LINCOLN-LANCASTER COUNTY HEALTH DEPARTMENT

FILE NO. 2089-C

INDIVIDUAL SEWAGE SYSTEM CONSTRUCTION — TYPE OF PERMIT

T11N; R6E; Sec 9; Bk 2; Lot 5; Valleyhome Farms — LEGAL DESCRIPTION

ADD ON
ABSORPTION
FIELD

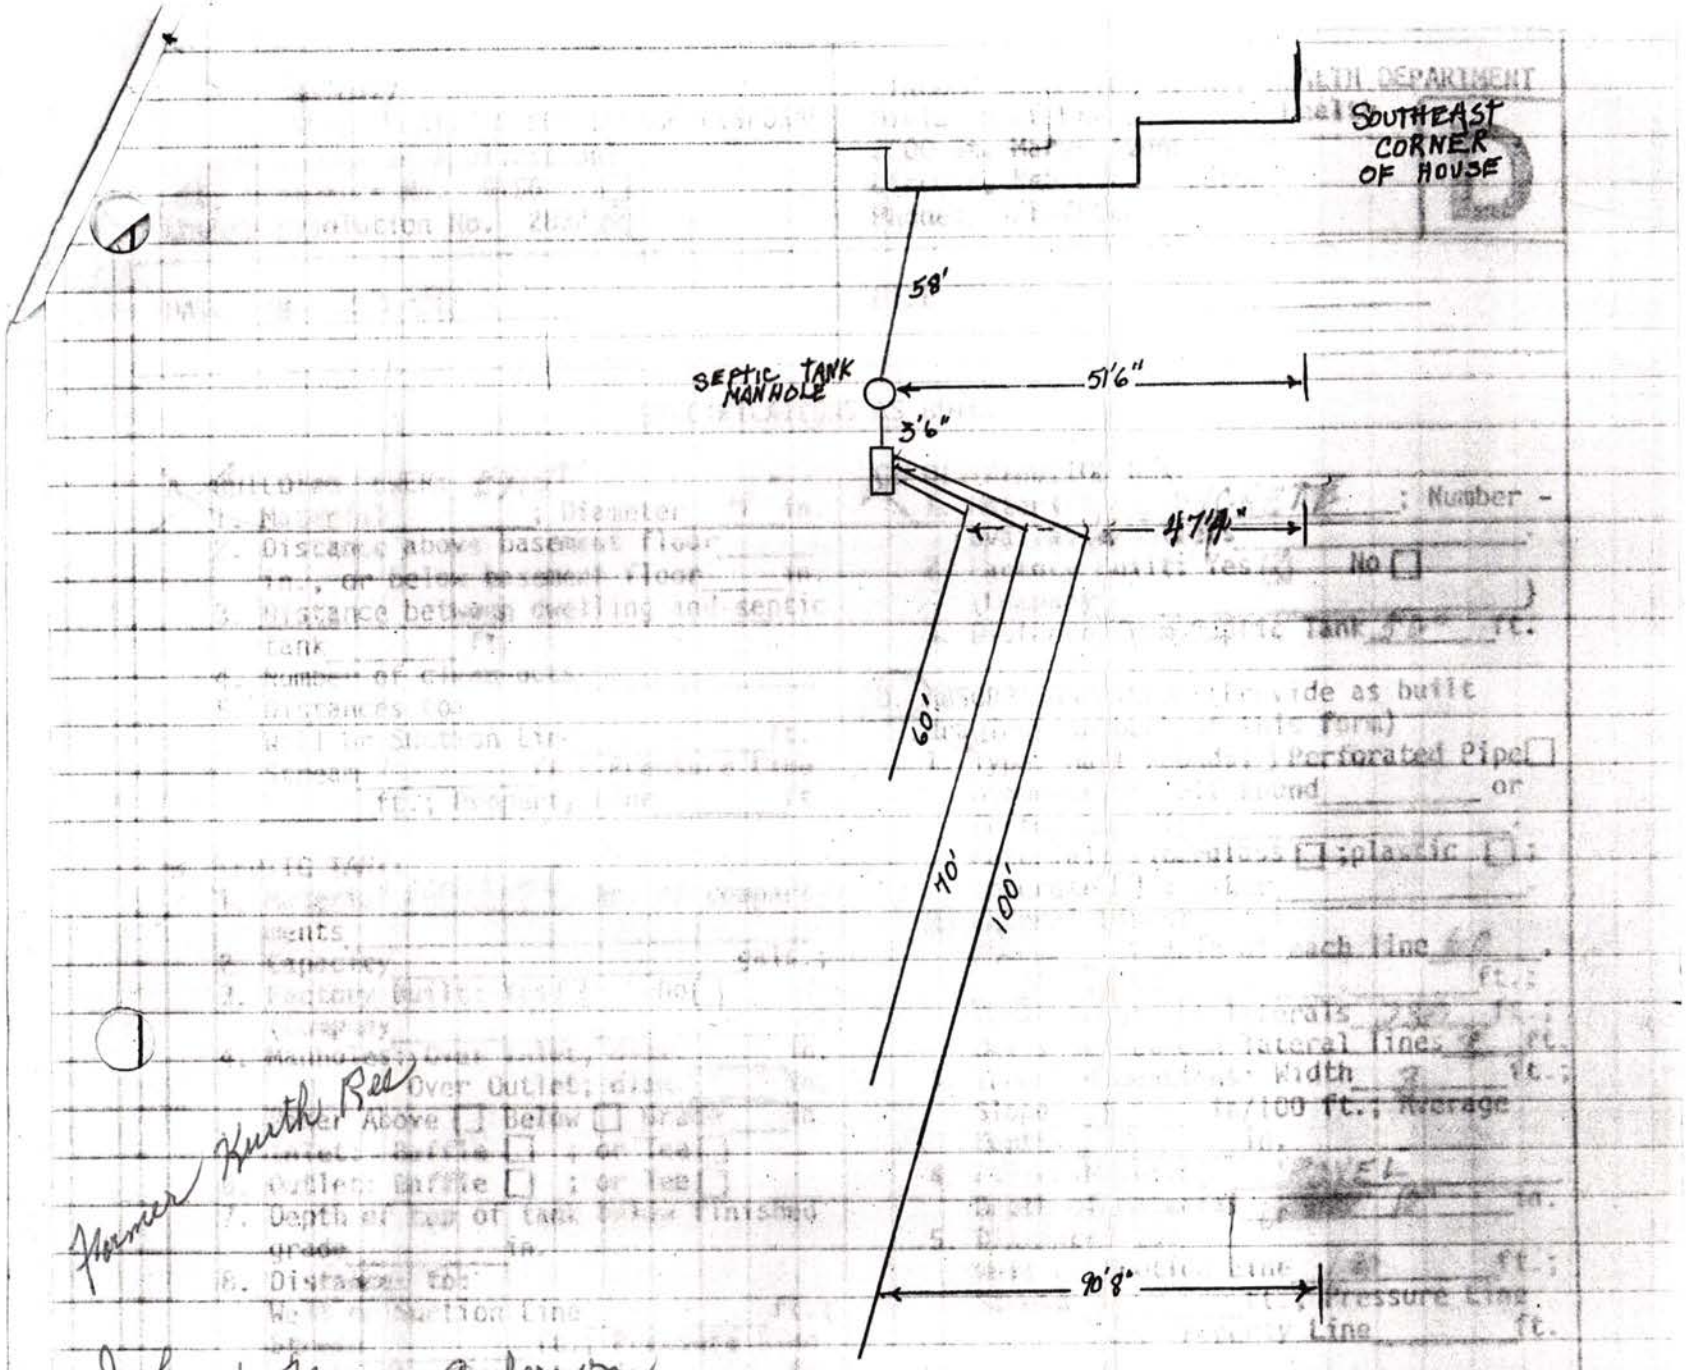
Comments: Appears not to be sufficient subsurface lateral for this soil type. Thus a provisional approval. Recommend checking to see if septic tank needs pumping 200 extra feet of lateral added on 5-22-91
